PRELIMINARY BCA REPORT
SSDA

Macquarie University
Arts Precinct Project

Revision: 2
10 August 2017
Project No.: 170093

This report comprises a review of the Schematic Design documentation for the proposed Macquarie University W6 & W6A Redevelopment against the NCC Building Code of Australia 2016 (BCA)

Figure 2: Distances between buildings to be confirmed

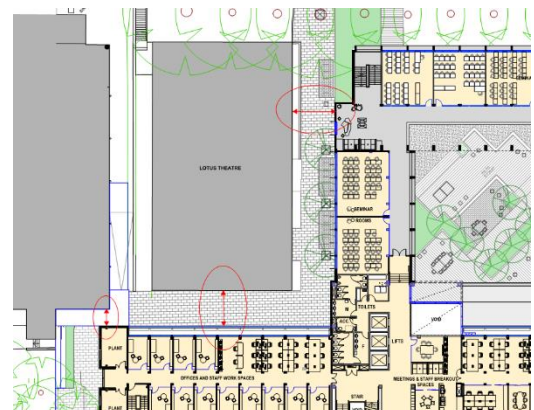
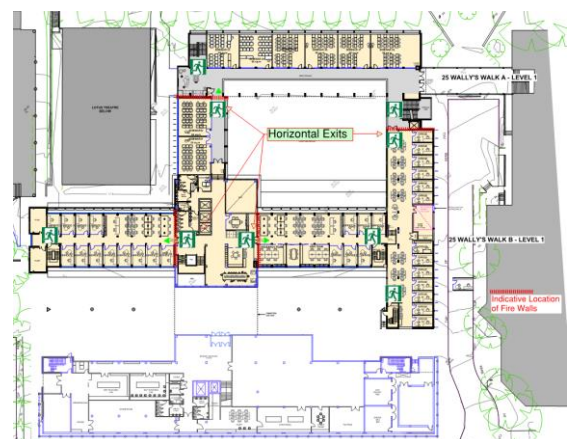
While the existing and proposed buildings are noted as generally more than 6m from any other buildings on campus, the setbacks circled to the right in Figure 2 are to be confirmed in order to determine if any protection is required. In this regard, protection may also be required to the adjoining buildings in addition to the W6 precinct where the setbacks are less than 6m.

Where protection is required, protection must comply with BCA clause C3.4 e.g. external wall-wetting sprinklers, or a fire engineered Performance Solution documented.

Figure 3: Indicative Exit Locations

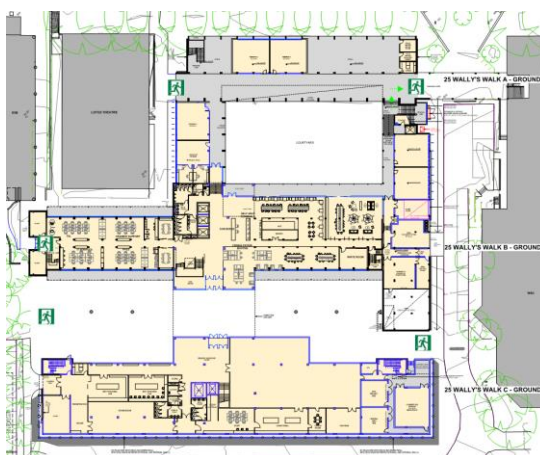
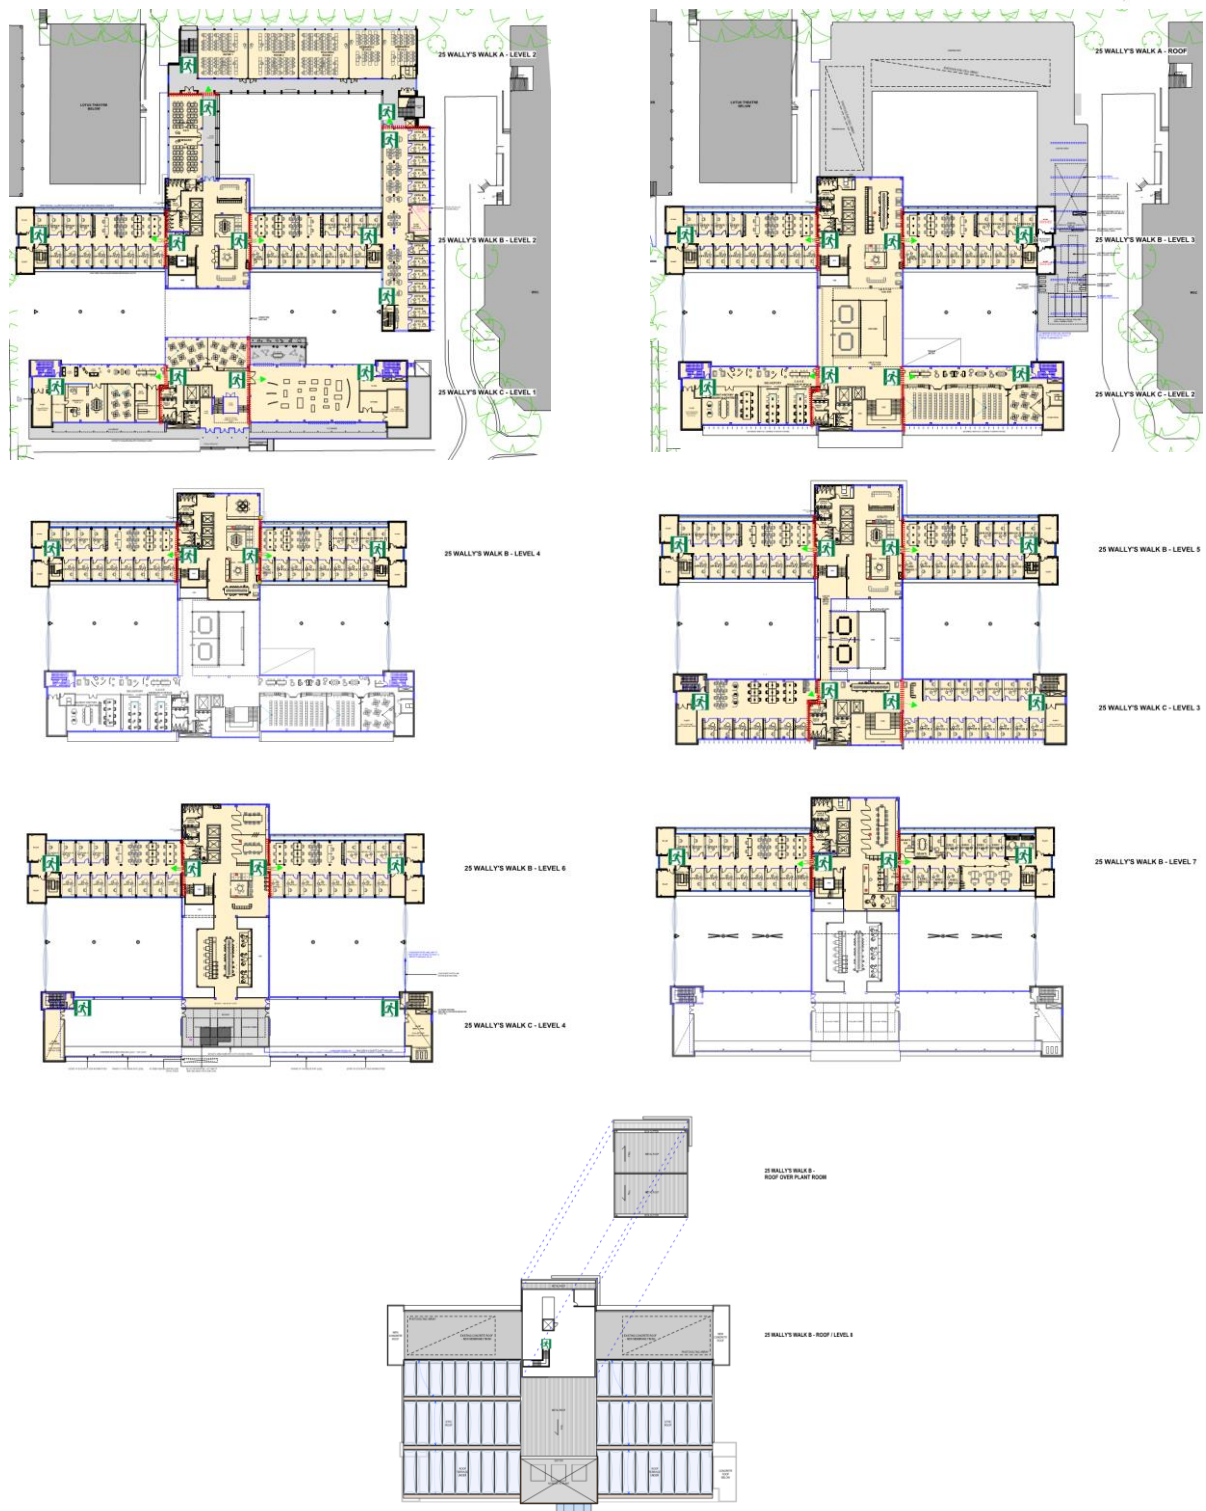
1. Indicative locations of exits (including Horizontal Exits) serving the building are shown in Figure 3 below.

2. The BCA DTS provisions state that no point on the floor should be more than 20m to an exit, or from a point at which travel in different directions to two exits is available, in which case the maximum distance to one of those exits is 40m. The referenced plans show that travel distances generally comply with the BCA DTS provisions with the exception of travel distance to one of two alternative exits from within the covered area/atrium between Buildings B & C, which will necessitate a fire engineered Performance Solution.
3. The BCA DTS provisions state that the maximum distance between alternative exits (when measured through the point of choice) is 60m. While compliance is readily achievable, a fire engineered Performance Solution will be required to allow extended distance between alternative exits within the covered area/atrium between Buildings B & C.

5. The discharge of the fire isolated exits, particularly into the proposed covered area, will necessitate a fire engineered Performance Solution.

APPENDIX A – PRELIMINARY FIRE COMPARTMENT PLANS

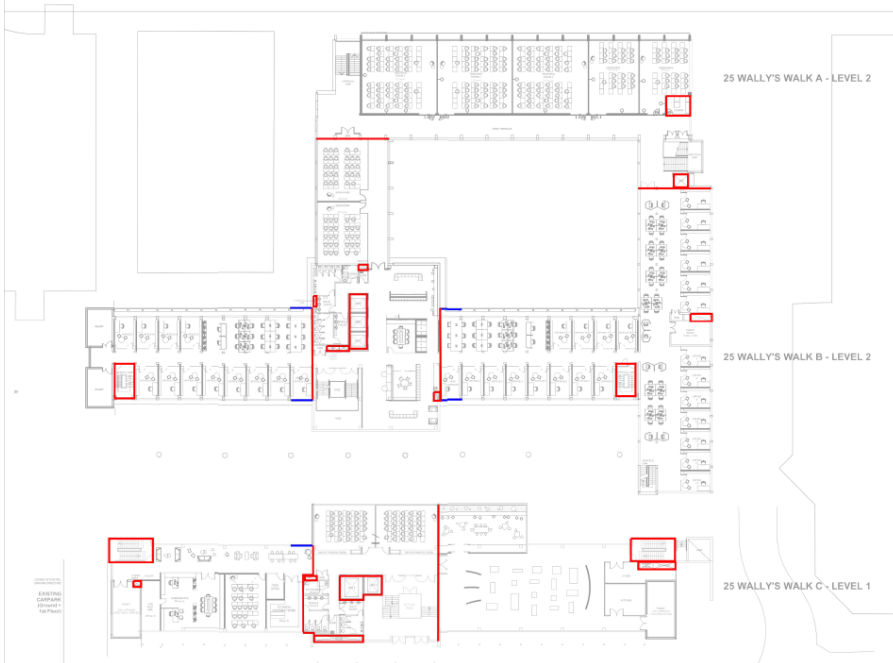
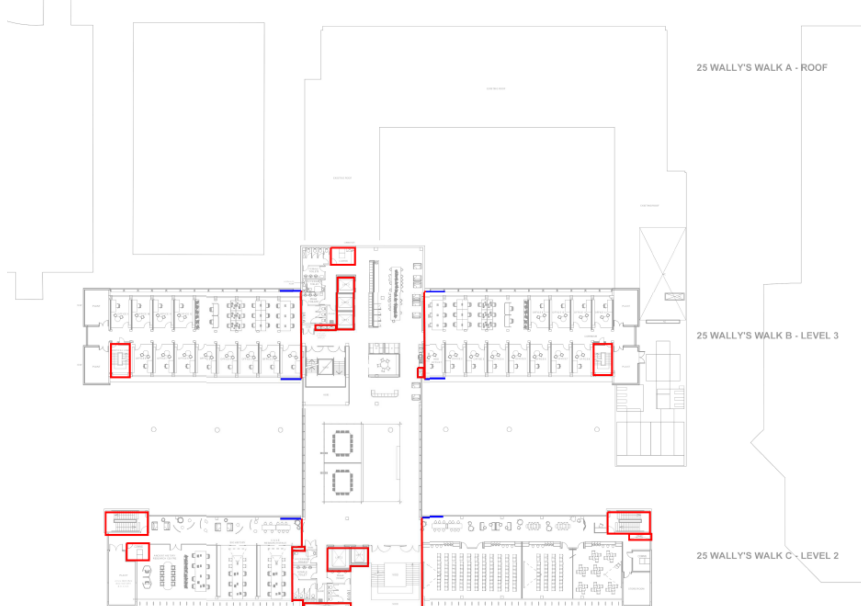
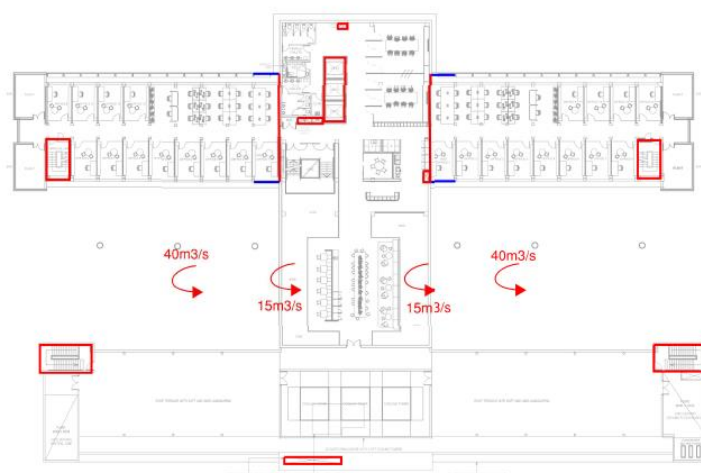
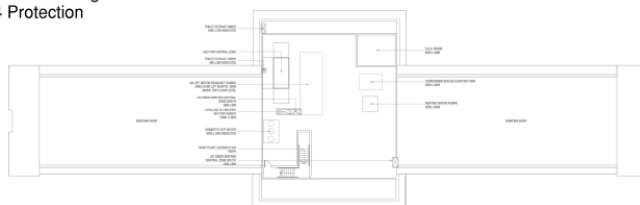
The extent of fire compartmentation will need to be developed through consultation between the Architect, appointed Fire Safety Engineer and BM+G. In this regard, preliminary fire compartment plans have been developed by the Fire Safety Engineer and are provided in Appendix A.

The preliminary fire compartment plans also indicate the extent of protection of openings in external walls of different fire compartments which will be rationalised under a fire engineered Performance Solution.
